IMPERIAL ROAD DESIGN MANUAL
REVISIONS January, 2014

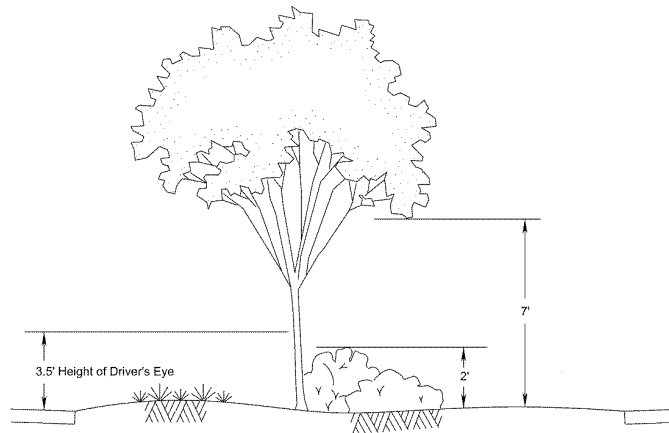
- Page B(1)-43 – Revised the following language to section “D” name from; “*STREETSCAPE*” To; STREETSCAPE “*AND LANDSCAPE*”.

Revised the following language in the second paragraph under “*STREETSCAPE AND LANDSCAPE*” from; “*Planting strips, located between the curb and sidewalk and parallel with the street, shall be 6 feet or more in width. Care should be used to ensure that larger planting strips do not push pedestrian crossing areas back from the intersections by requiring a larger curb radius. To maintain sight lines, trees and other objects should be restricted from corners for distances of 30 feet on all sides measured from the end of the curb return radii. Along all planting strips, the area between 2 and 7 feet above ground should be maintained as a clear zone to preserve sight lines and accommodate pedestrians.*” To; Planting strips, located between the curb and sidewalk and “*within unpaved medians*” parallel with the street, shall be 6 feet or more in width. “*All plantings shall be located a minimum of 3 feet from the back of curb.*” Care should be “*taken*” to ensure that larger planting strips do not push pedestrian crossing areas back from the intersections by requiring a larger curb radius. “*Trees, vegetation and other objects shall be spaced so that the sight distance triangle for intersection sight distance or stopping sight distance is free of any obstructions that may block the driver’s view of potential conflicting vehicles and/or pedestrians. To maintain sight lines,*” trees, “*vegetation*” and other objects “*shall*” be restricted from corners for distances of 30 feet on all sides measured from the end of the curb return radii “*as shown in the diagram below.*”

Mini-Roundabouts

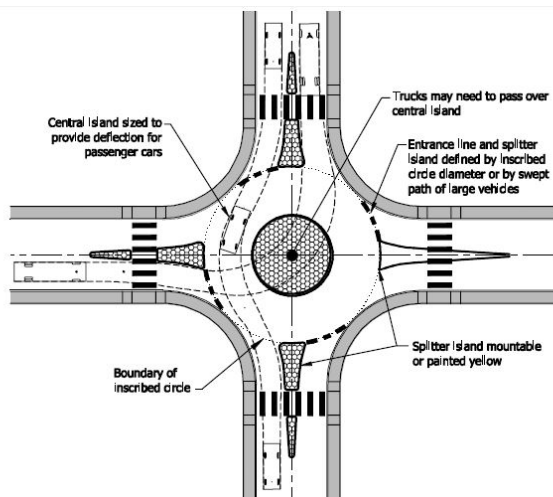
- Page F-46 – Added the following language;

Mini-Roundabouts are applicable to low-speed environments ≤ 35 miles per hour. Because they adapt to existing boundaries by providing a fully traversable central island, a mini-roundabout can be a low-cost solution for improving intersection capacity and safety without the need for acquiring additional right of way. The suitability of a mini-roundabout depends on:

- 1) *Traffic Volumes (comparable ADT from each approach roadway)*
- 2) *Truck Volumes $\leq 5\%$*
- 3) *Frequency of School Bus*

Mini-Roundabouts should meet the following geometric design criteria:
